Consumer and  
Corporate Affairs Canada

Legal Metrology  
Branch

File N°: 06635  
Project: AP-GL-91-0020

This is in response to your recent notification given in accordance with the Electricity and Gas Inspection Regulations, Section 13. It is noted that the meters listed in the appendix hereto are to be fitted with plastic index covers.

**METER PRESSURE TAP**

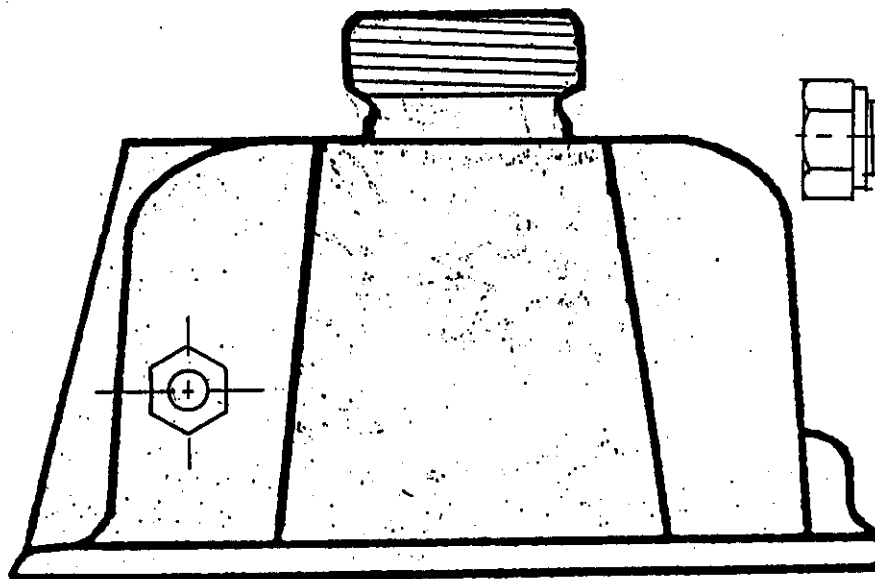
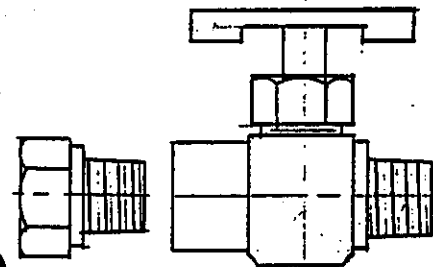
- Sprague/Schlumberger meters, types 240, 400, 400A, 675 and 1000 may have a pressure tap hole located on the top cover, right front side for the purpose of meter pressure measurement required when converting metered volumes to base (standard) pressure conditions. This pressure tap will consist of a Petes plug type fitting.

I am advised by the Electrical Metrology Laboratory that their evaluation of the proposed modifications indicates that they do not adversely affect the performance of the meter. Accordingly, your notification is acknowledged and the modifications are accepted as being included within the above-noted approval. All recipients of the approval notice are being informed by copy of this letter.
